10/5/2012**PERMIT**P 538074

**ON-SITE SEWAGE DISPOSAL SYSTEM
TANK REPLACEMENT
HOWARD COUNTY HEALTH DEPARTMENT
BUREAU OF ENVIRONMENTAL HEALTH**D'Amore Construction Company

15005 Scottswood Court

CUTRONGO SEPTIC TANK REPAIR/REPLACEMENT SCALE 3/8" = 1'-0"

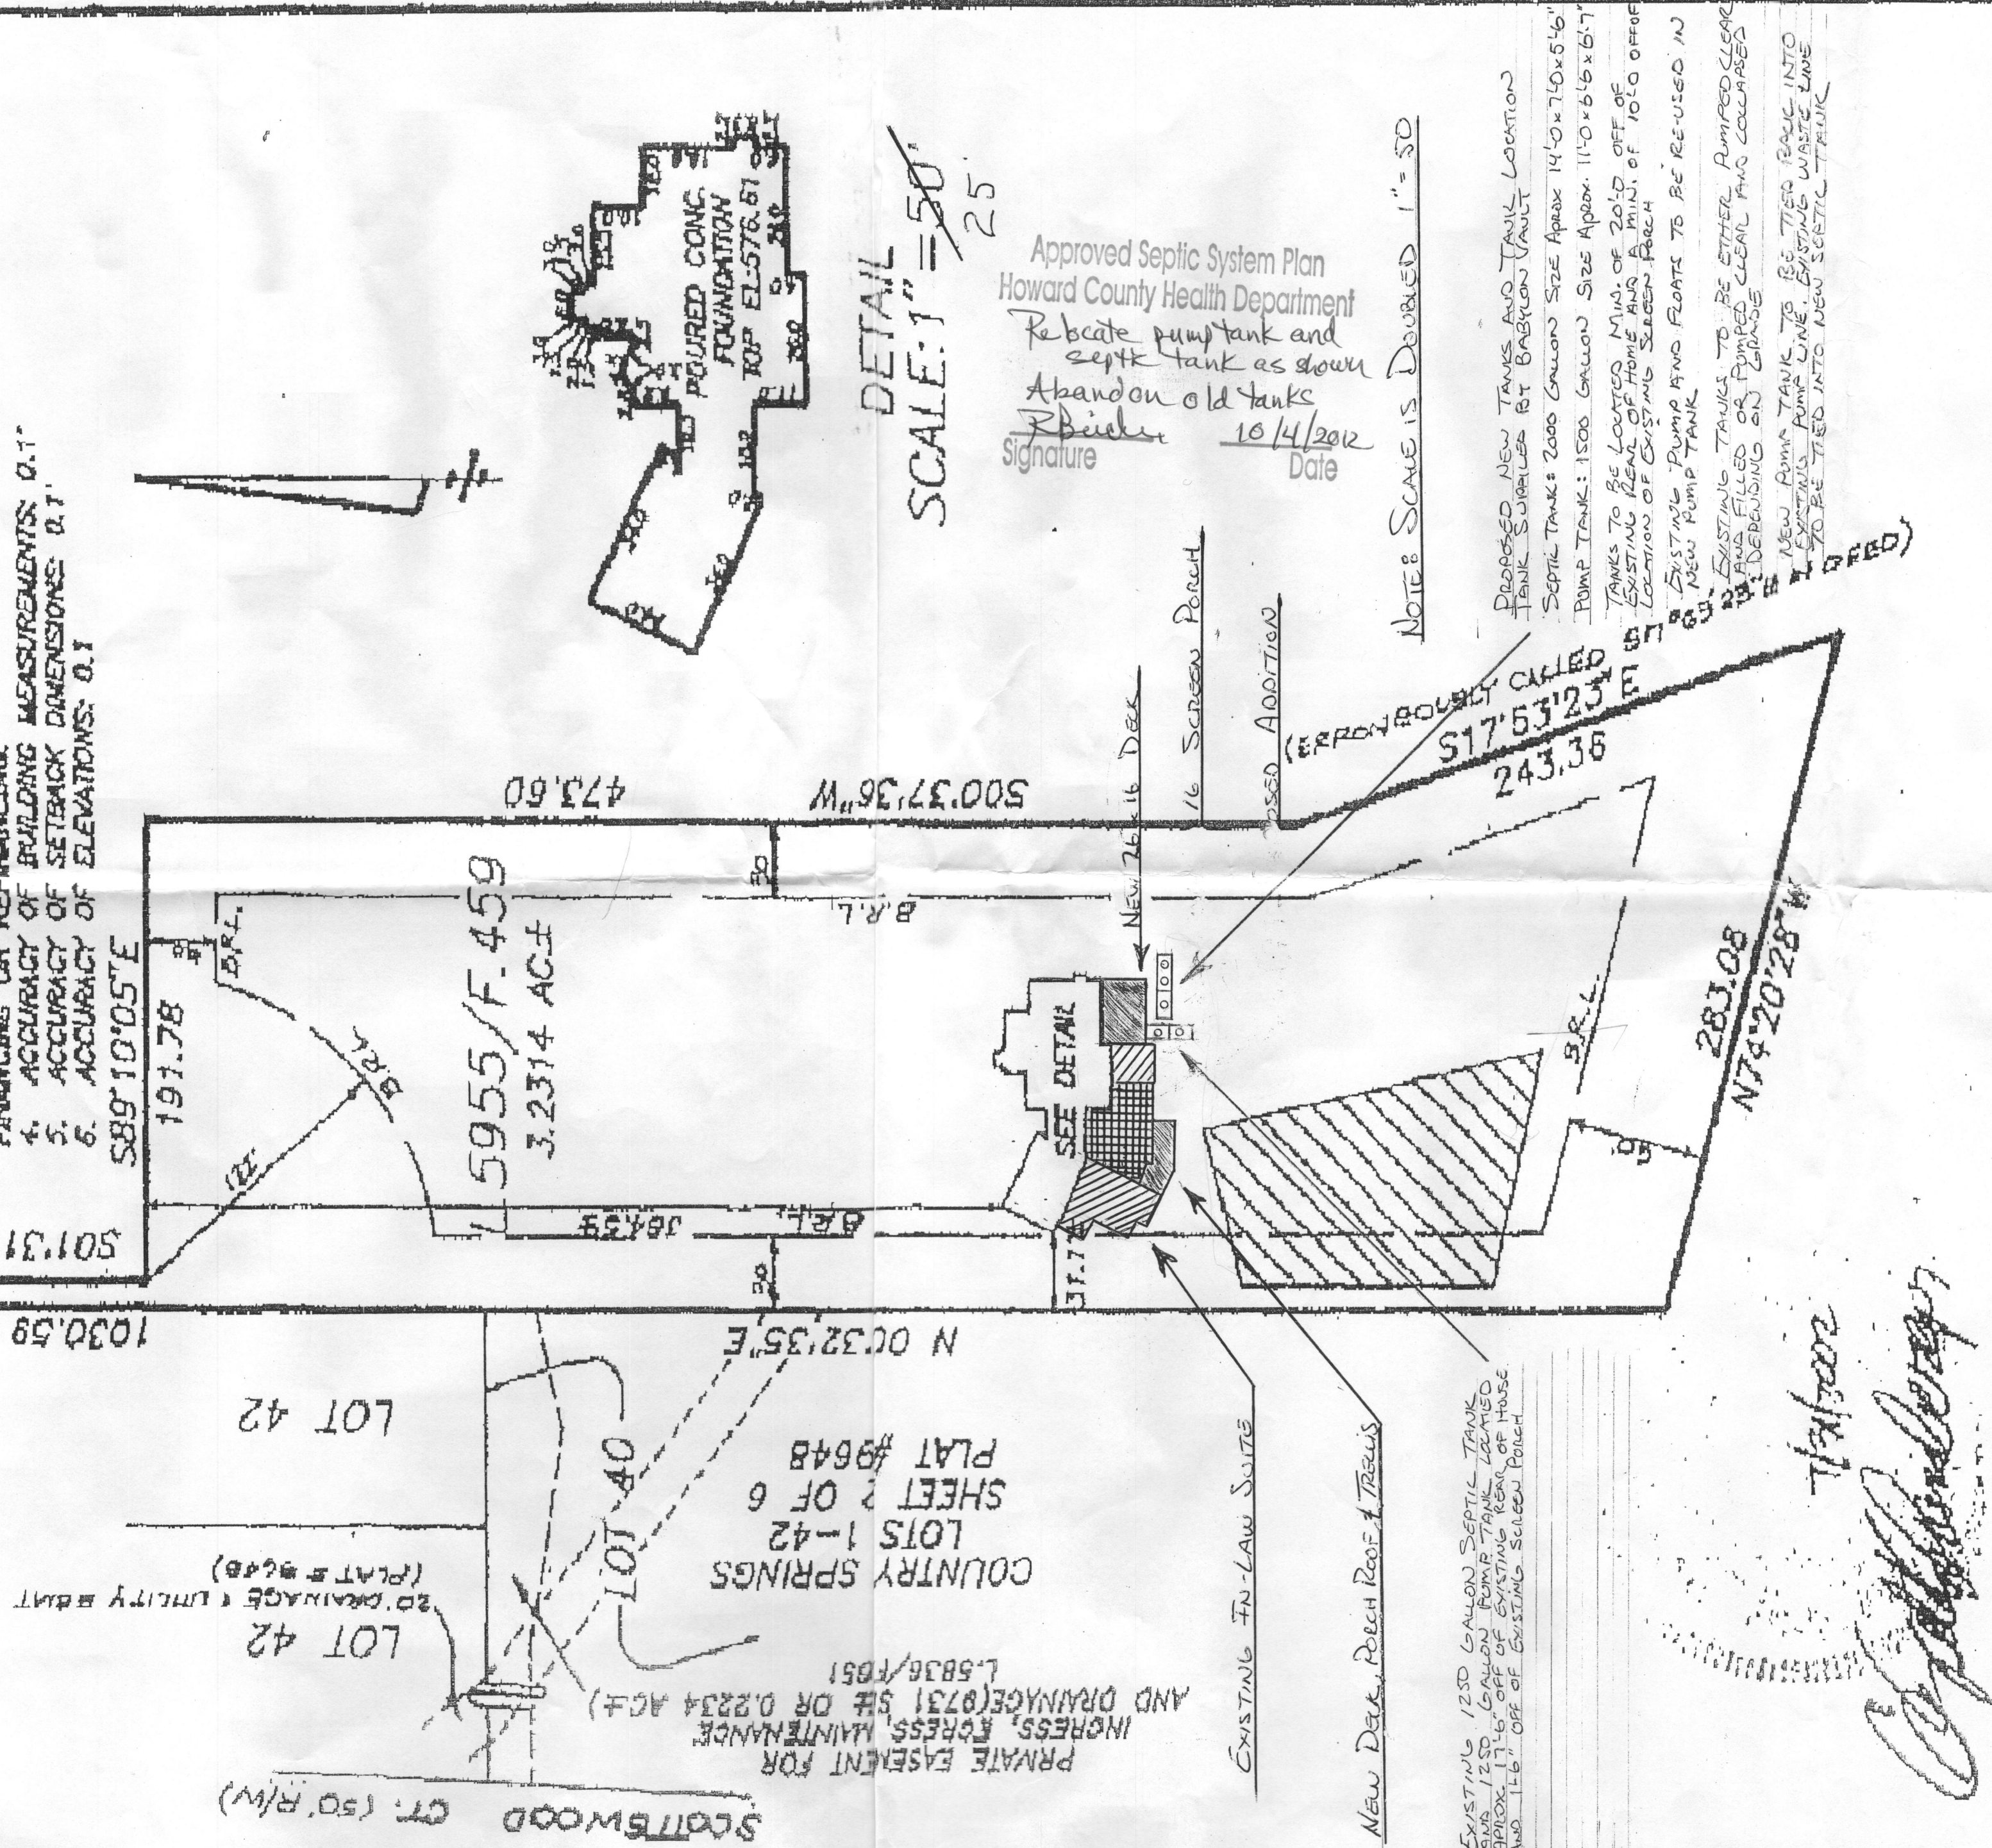
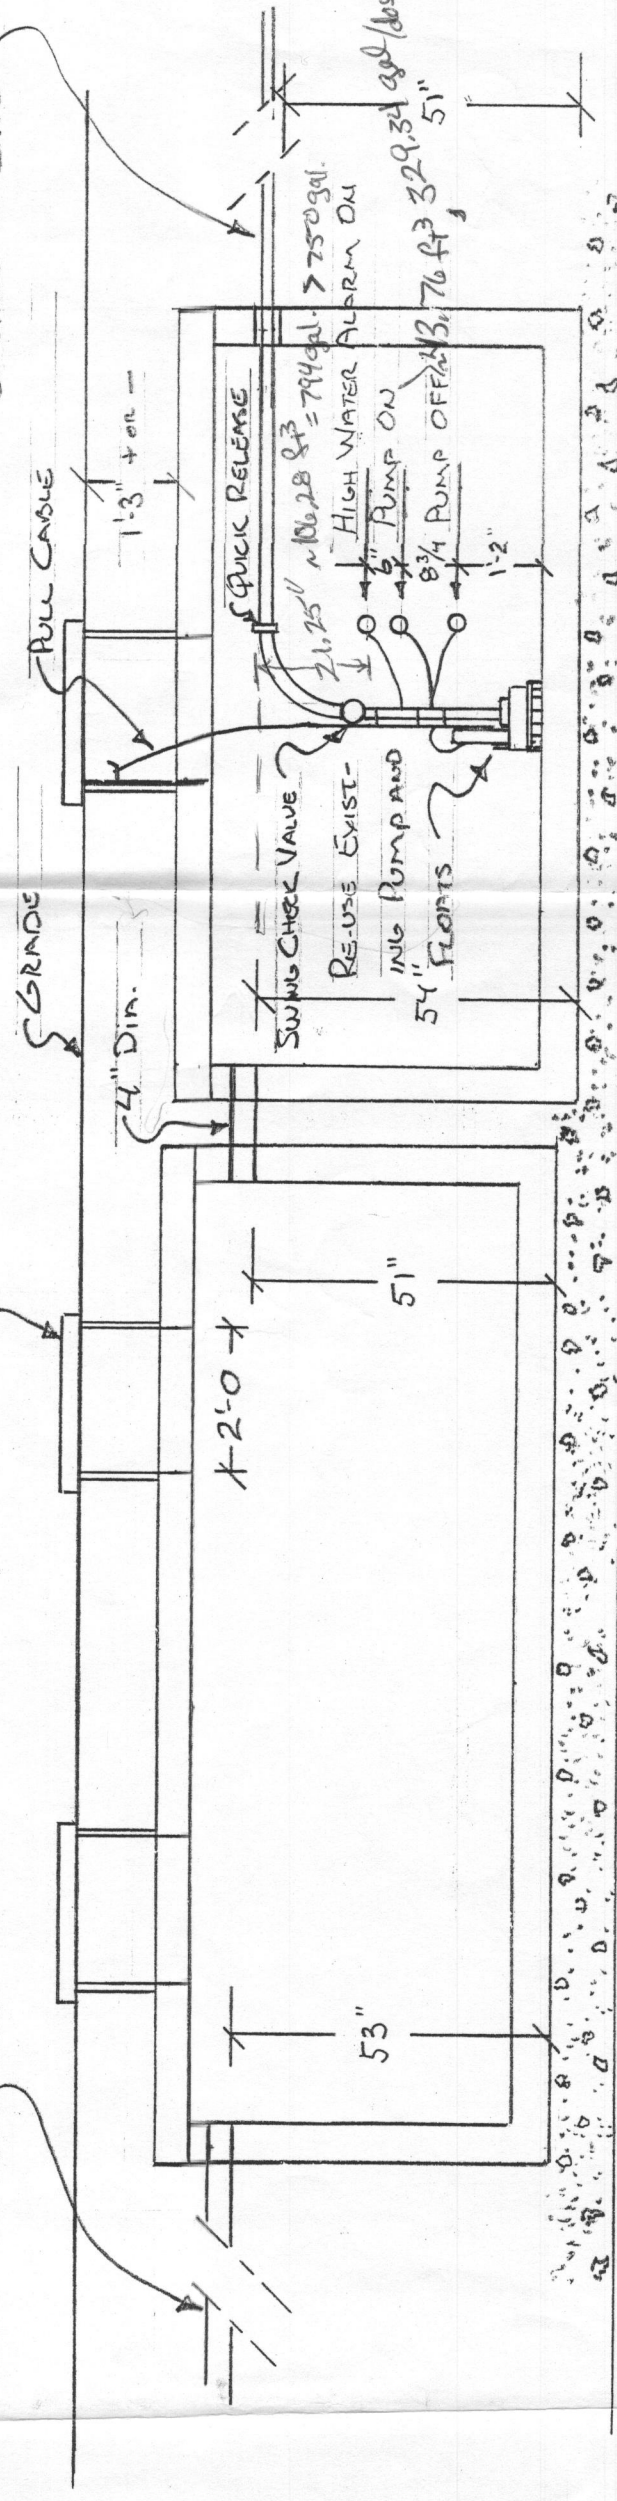
10/10/12 Install new S.T. and pump tanks as shown on approved by plan. The pump not very old. Will re-use. Pump must meet current code (i.e. 4" black under pump, separate float tree, junction box outside tanks if needed). Will need a pump/alarm test as well. (K)

10/18/12 Tanks set. Old tanks pumped and collapsed. Connected F.M. pump set. (1/2 hp Zanker). Electrical work not finished. need test of p/a. (K) 10/19/12 Pump/Alarm test OK.

Pump Tank Design
approved as shown
Must pass Pump & Alarm inspection
